DARWIN CITY COUNCIL

TOWN PLANNING COMMITTEE

WEDNESDAY 5 AUGUST 2009

10 OFFICERS REPORTS**10.1 Planning Scheme Amendment PA2009/0892 Proposed Changes to Provisions Relating to Demountable Structure.**

elevation 2 / 4
SCALE 1 : 100

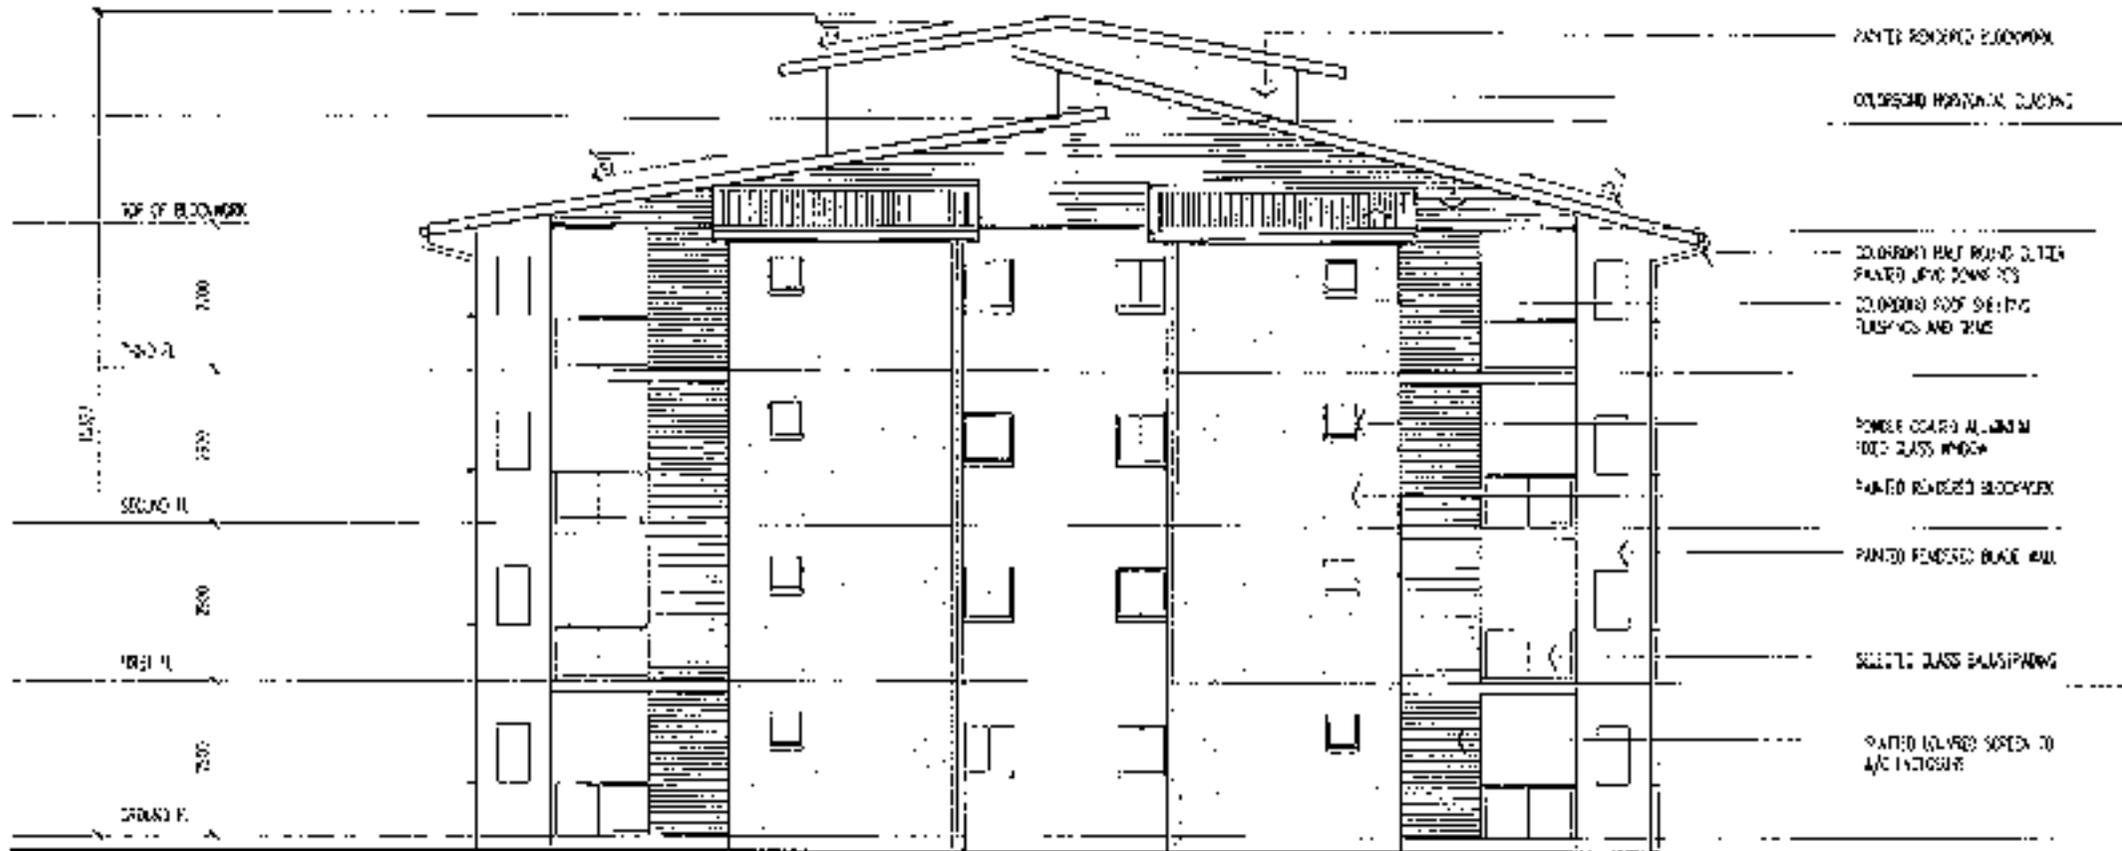
- a). **Council requests the Authority requires an additional plan to demonstrate stormwater drainage arrangements for the proposed development.** The site plan shows stormwater drainage for the car park area but fails to demonstrate how stormwater will be collected from the roof of the proposed building and be discharged underground to Council's stormwater drainage system.
 - 1). The stormwater plan should include details of site levels after the completion of the development and the location of Council's drainage collection points, adjacent to the site.
 - 2). Council requires a stormwater drainage plan to confirm that it is technically feasible to collect stormwater on the site and dispose of it into Council's stormwater drainage system. It is also necessary to ensure that no stormwater will sheet flow into the road reserve or onto adjoining properties.

- b). **Council requests the Authority requires an amended site plan demonstrating a waste bin enclosure of sufficient dimensions to store 7 x 240 litre bins.** Council requires a development of 16 multiple dwellings to include a waste-bin enclosure large enough to store 7 x 240 litre bins (4 x general garbage bins and 3 x recycling bins). The usable area of the waste bin enclosure shown on the site plan is approximately 2.6m (length) x 2.5m (width), which is slightly too small to store the required number of bins. A waste bin enclosure of minimum 2.8m (length) x 2.6m (width) should provide sufficient space to store the bins and allow room for residents and the service contractor to access and move the bins in and out of the enclosure as required.

site plan
SCALE: 1:250

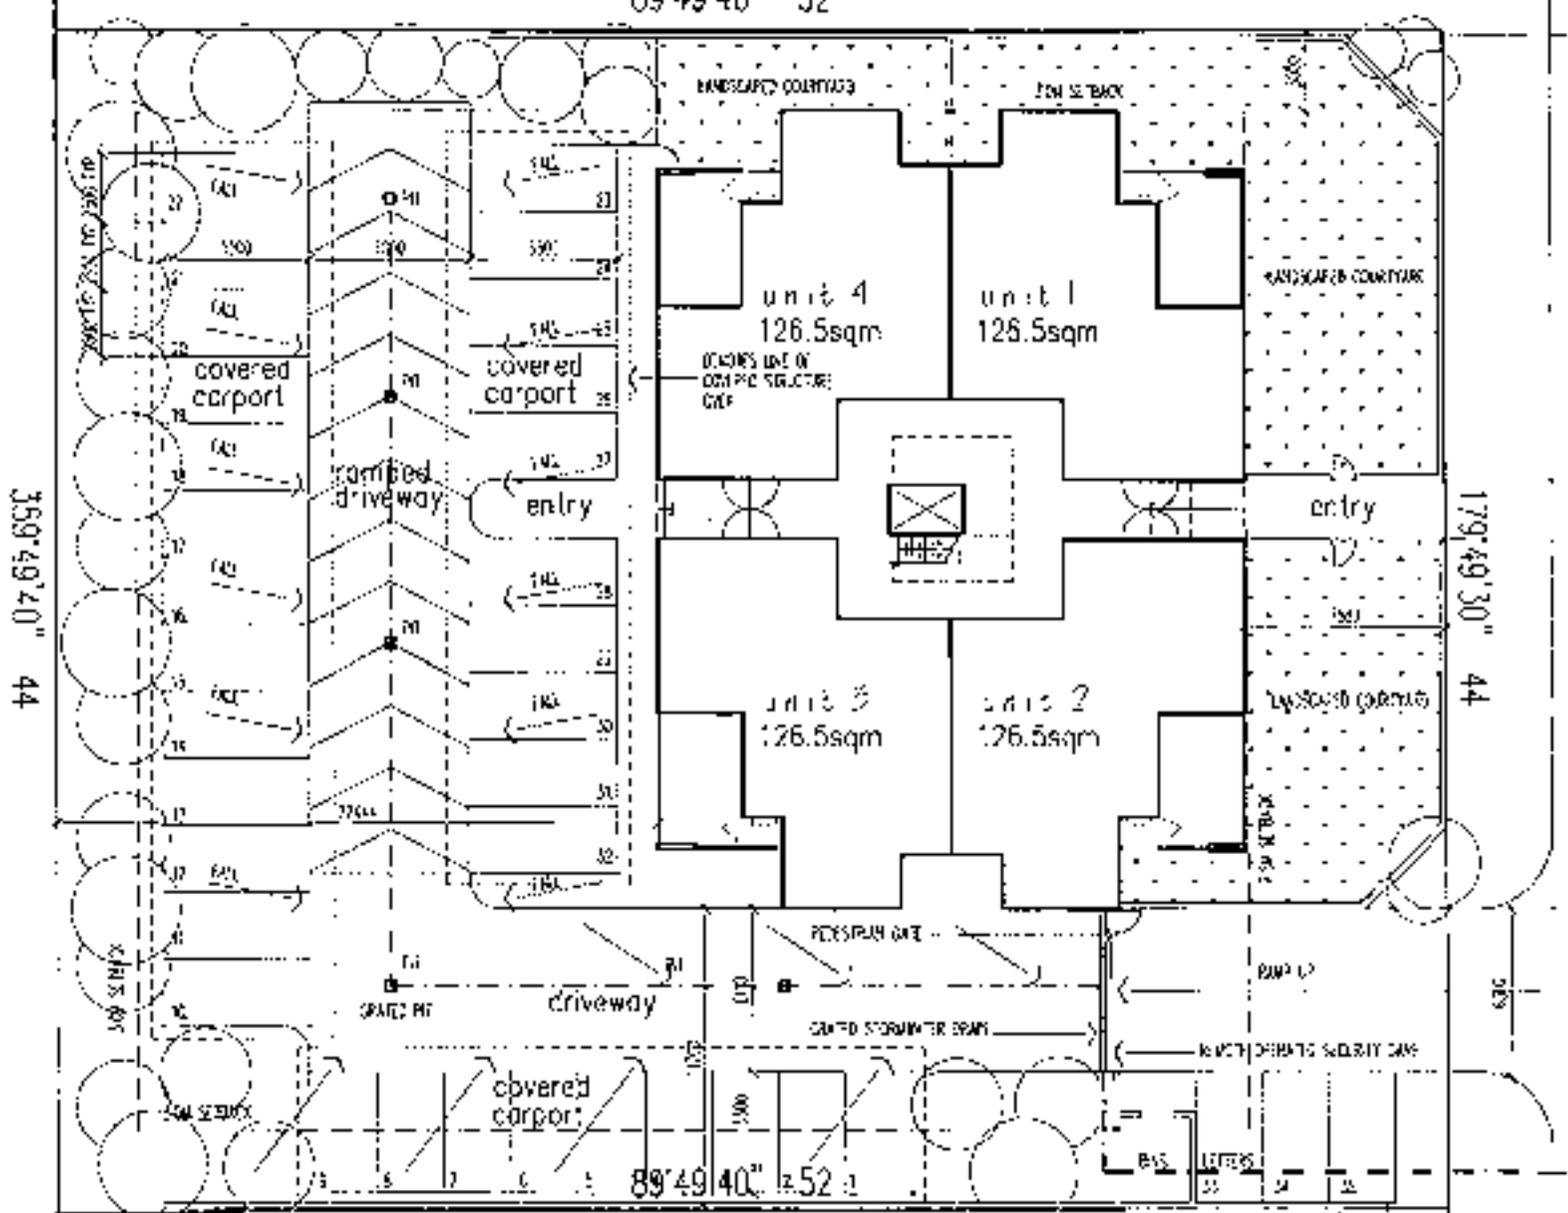
- a). **Council requests the Authority requires an additional plan to demonstrate stormwater drainage arrangements for the proposed development.** The site plan shows stormwater drainage for the car park area but fails to demonstrate how stormwater will be collected from the roof of the proposed building and be discharged underground to Council's stormwater drainage system.
 - 1). The stormwater plan should include details of site levels after the completion of the development and the location of Council's drainage collection points, adjacent to the site. It appears from the submitted detailed survey plan that Council's existing drainage collection point (side entry pit) adjacent to the site in Villaflor Crescent may be located in the same location as the proposed vehicle crossover for the site. If such a conflict does occur, the applicant will be required to relocate the drainage

- b). The applicant's site plan shows a circular outline of a tree or shrub located within the sightline of drivers exiting the site. The applicant should be advised of Council's requirement that sight lines shall be provided at crossovers to public streets to the satisfaction of the General Manager of Infrastructure, Darwin City Council. No wall, fence or tree exceeding 0.6 metres in height shall be constructed or planted in front of the sight line.

- 2). Council requires a stormwater drainage plan to confirm that it is technically feasible to collect stormwater on the site and dispose of it into Council's stormwater drainage system. It is also necessary to ensure that no stormwater will sheet-flow into the road reserve or onto adjoining properties.

- Sight lines shall be provided at crossovers to public streets to the satisfaction of the General Manager of Infrastructure, Darwin City Council. No wall, fence or tree exceeding 0.6 metres in height shall be constructed or planted in front of the sight line.
